BA52_CP Colay Schematic
Intel Arrandale rPGA-989
PCH BGA 1071
2011-0503
REV :R2.0

modify notice

LVDS Conn w/Camera Module & Int Mic

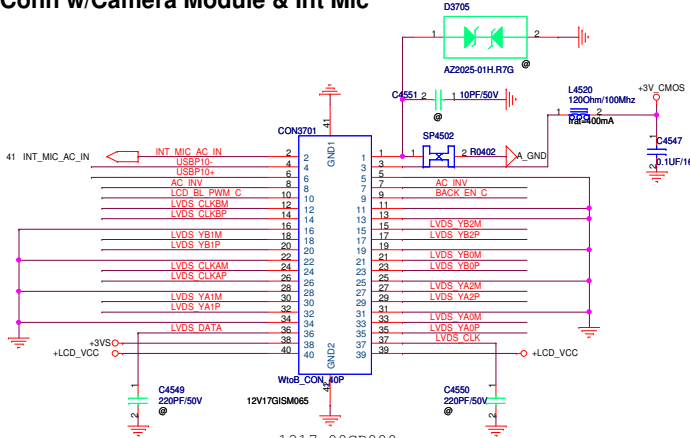
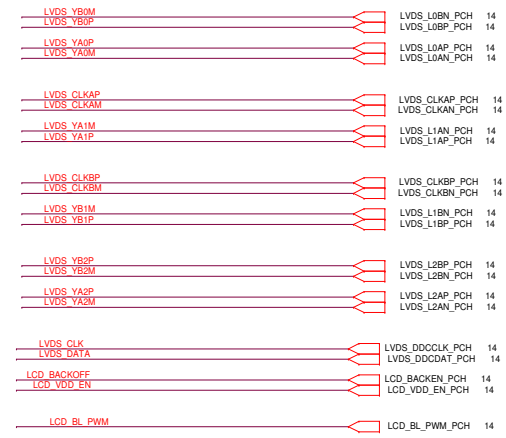
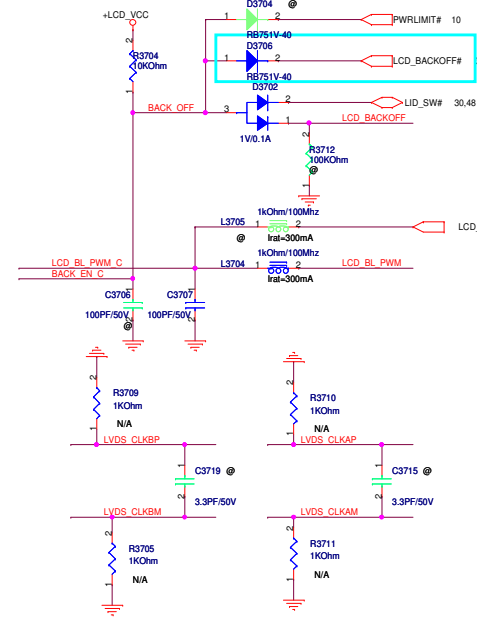
Modify LVDS Pin definition 0125-11 SR-43

Configuration for ALC269

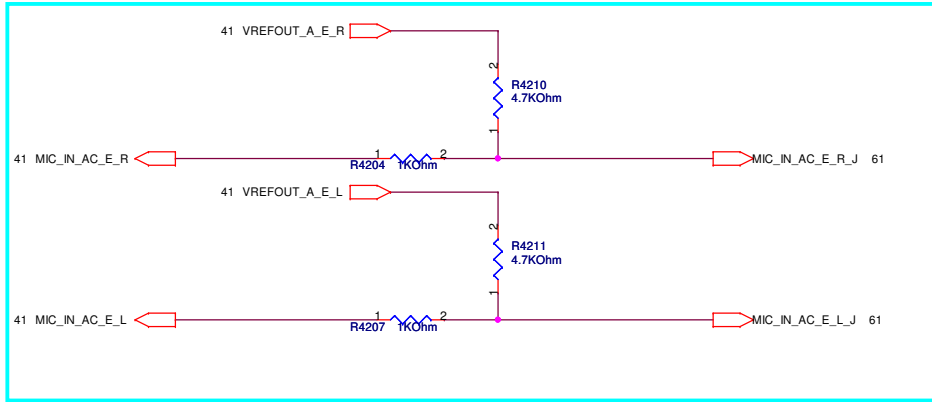
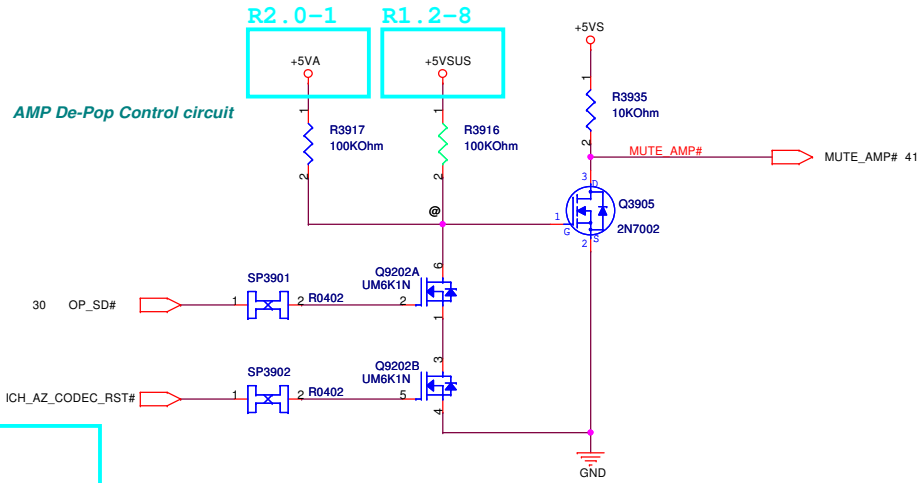
R1.2-6
Change to stereo MIC

Modify De-Pop circuit
SR-43
0125-11

Touch Pad Button/ Hall Sensor

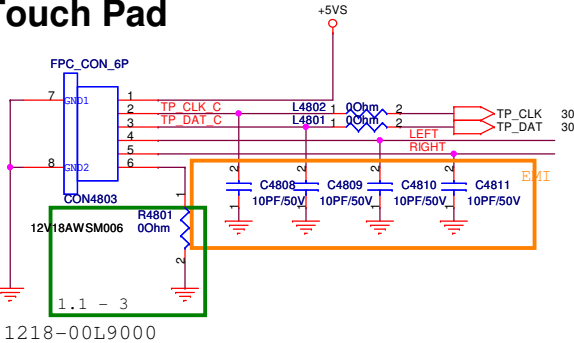
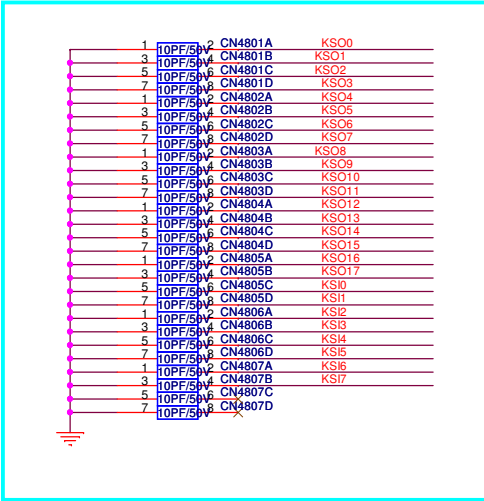
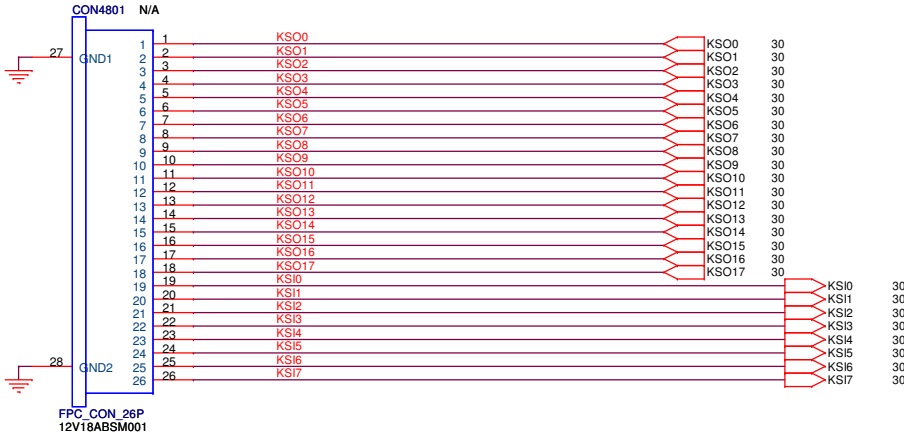
Remove TP button circuit

HDD FOR CABLE

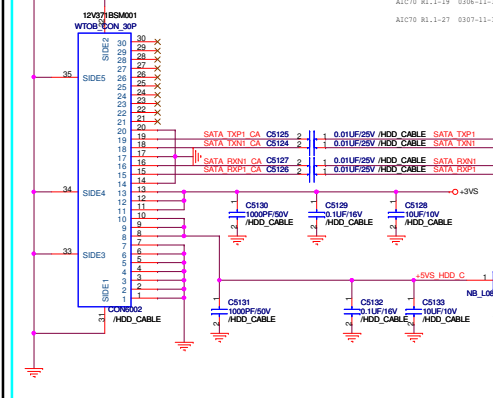
R1.2-13

AUDIO BOARD/w USB2.0 x2

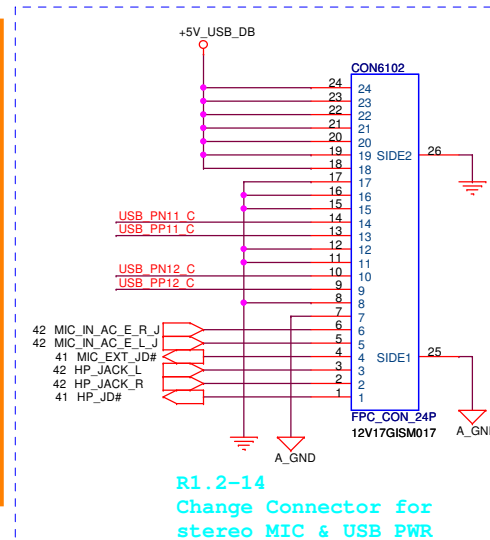
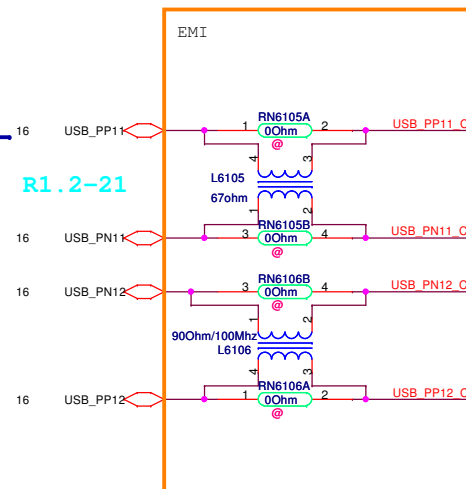
R1.2-14
Change Connector for
stereo MIC & USB PWR

LED (Main)

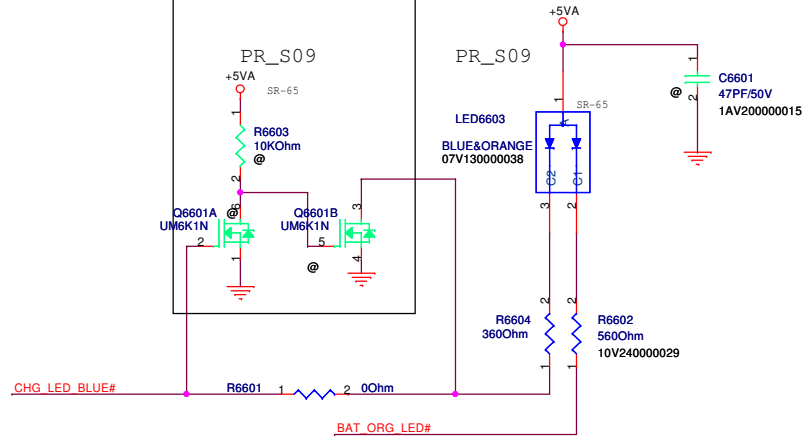
Remover LED circuit SR-18 0124-11

Modify LED circuit SR-28 0124-11 SR-39 0125-11

SUSB#_PWR POWER

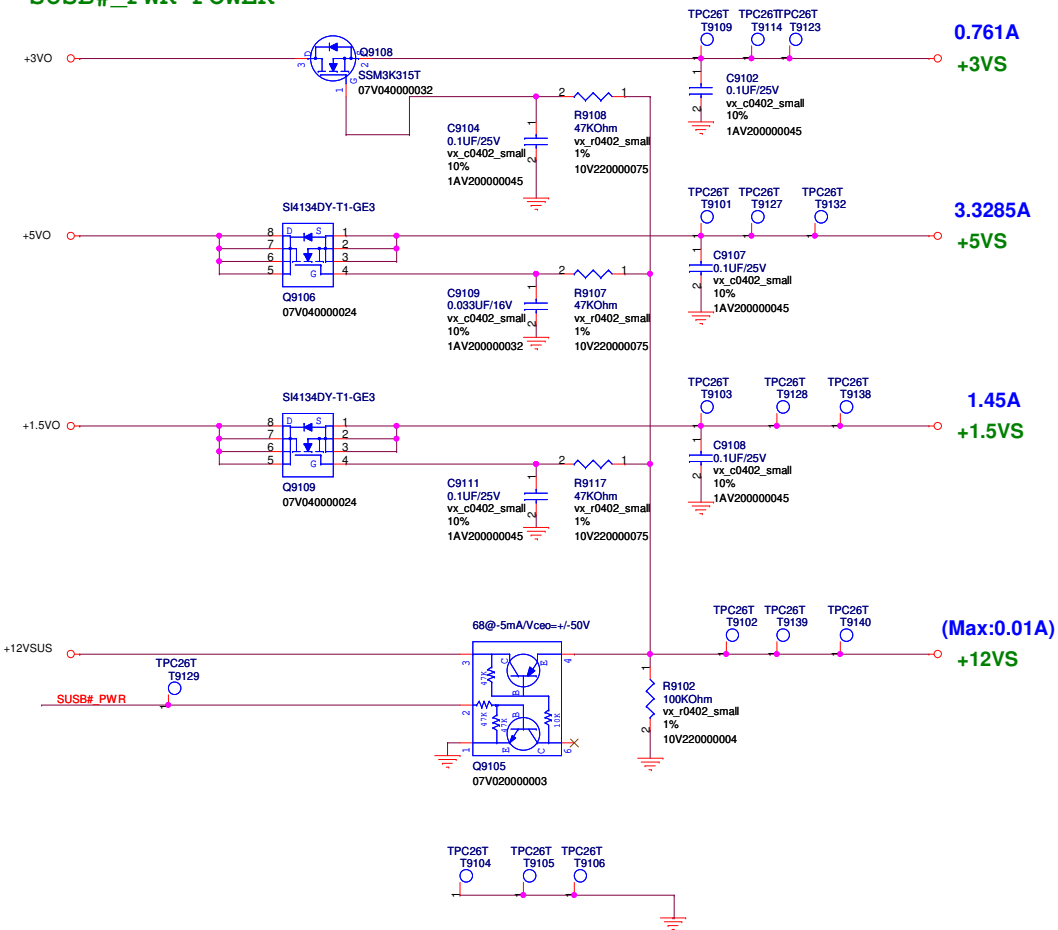
Use MAX17015 IC function to Cost down component

POWER LED 0129

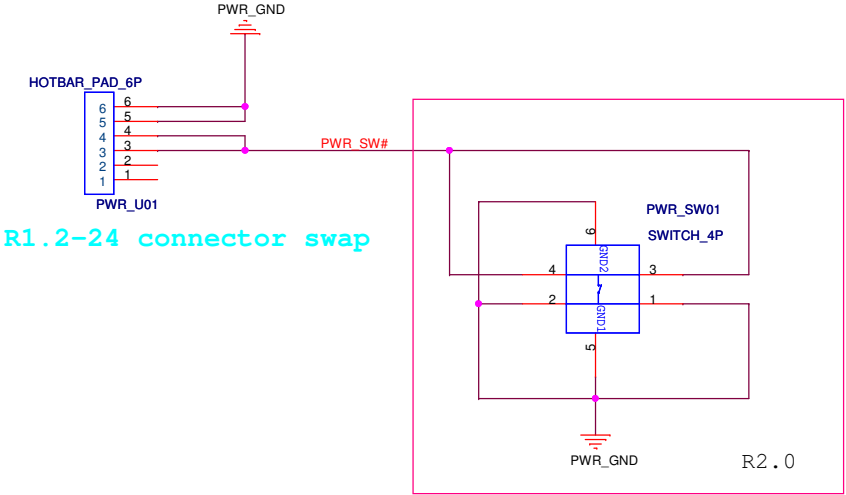
R1.2-24 connector swap
